**TOWN OF HERNDON, VIRGINIA
HISTORIC DISTRICT REVIEW BOARD WORK SESSION AGENDA
NOVEMBER 3, 2021
HERNDON POLICE DEPARTMENT, COMMUNITY ROOM
397 HERNDON PARKWAY
7:00 P.M.**

2. **APPLICATION FOR BUILDING ADDITION, HDRB #21-013**, to consider an application for an one-story with basement, 2,410 square foot, rear addition to a single family detached residence located at 809 Monroe Street, Herndon, Virginia, approximately 200' north of the intersection of Monroe Street and Madison Street, and further identified as Fairfax County Tax Map 0104-02-0035. The property is zoned as R-10, Single Family Detach Residential, and consists of 19,533 square feet of land. Applicant/Owner: Shane Todd-Williams.

Case Number & Type: HPRB #20-013; residential addition
Case Summary: One story addition with basement and deck to the rear of noncontributing single family detached house
Case Location: 809 Monroe Street

Subject: Pre-application HDRB case, 771 Center Street, Herndon Virginia

SK-2

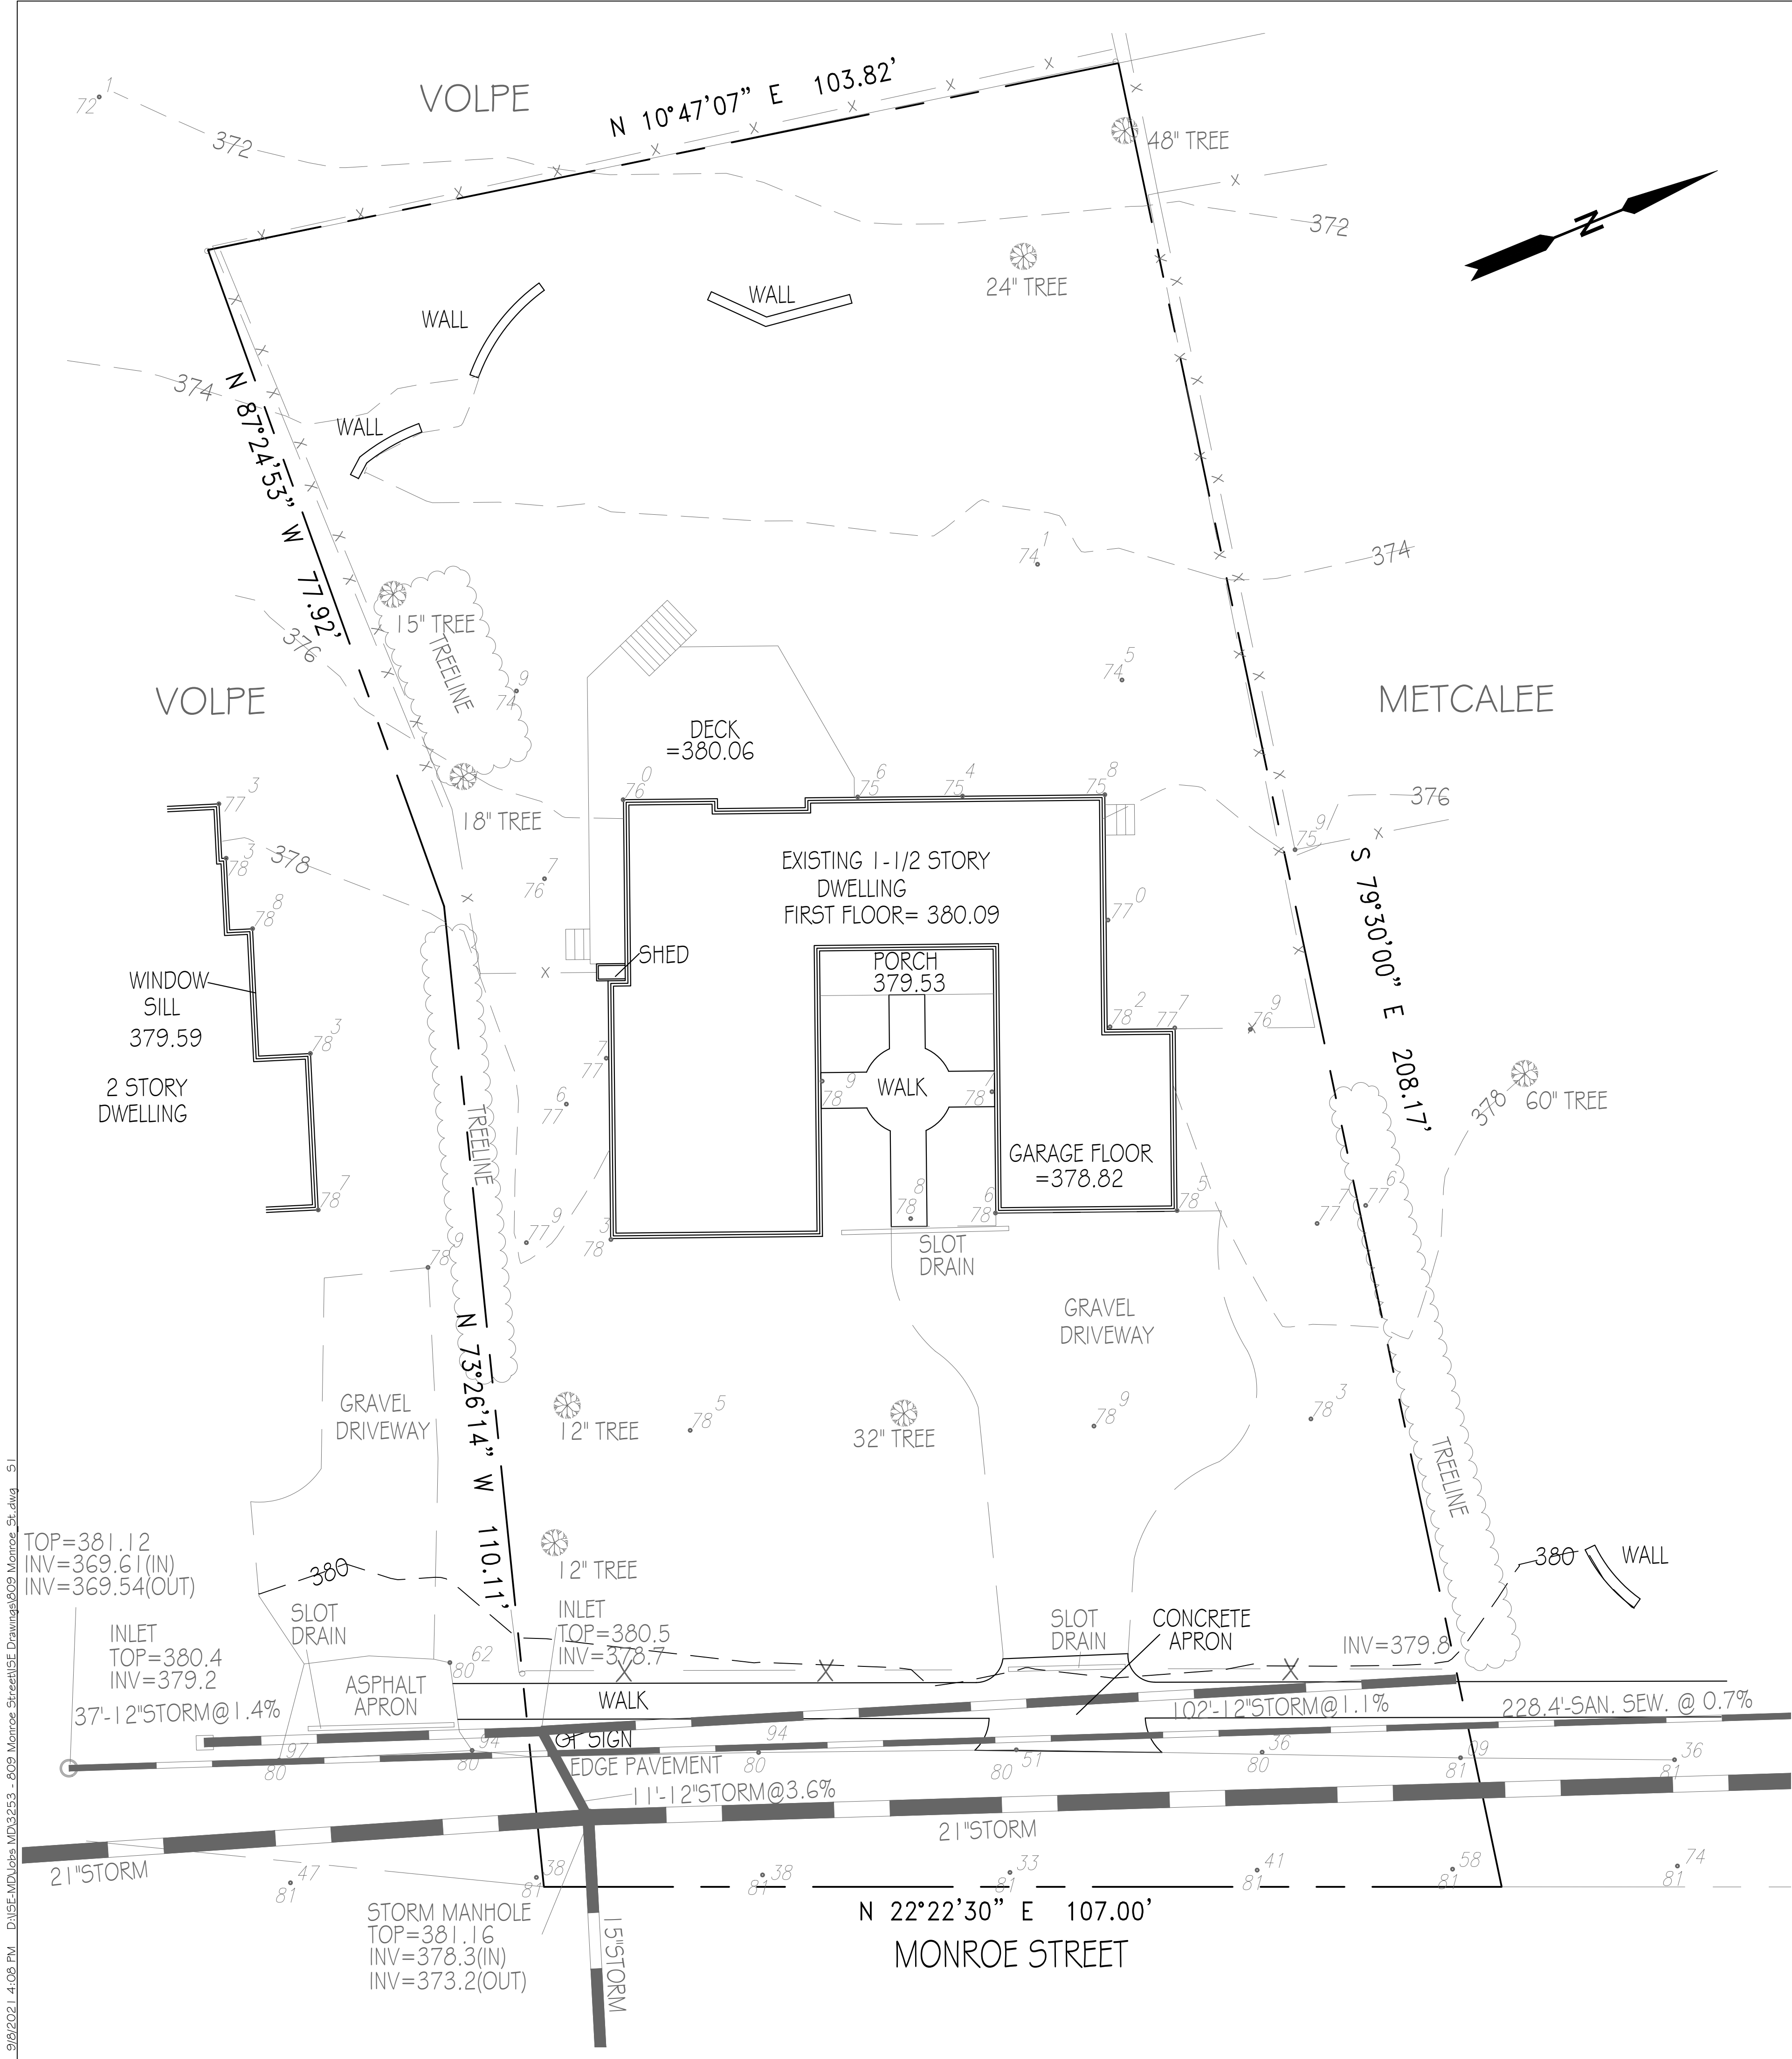
it is not an exact mirror, and the concept drawings indicate that the addition will be slightly narrower and shorter than the main part of the existing residence. This will help the addition to be understated and limit visibility from the right of way so that it has minimal impact on the surrounding area.

- Information regarding proposed exterior wall materials and finishes is limited at this point. Staff has requested additional details regarding this. It appears from the concept designs that the exterior siding will be a form of plank siding, which references portions of the existing front façade, but there is no indication about the material or color in relation to the existing structure.

2. There are a variety of windows portrayed in the concept designs with the most prevalent being undivided, 1-over-1 windows, normally in groups of two. way. No material, color, or functionality details are provided. The existing structure has a variety of window styles as well, though most are divided by muntins. It is unlikely that any of the windows of the new addition will be visible from the right of way.

3. No information is provided regarding doors, their style, material, functionality, or location though presumably there would be a door at the basement level and at the deck level. More information is needed in this area to make a proper assessment of character and design and appropriateness.
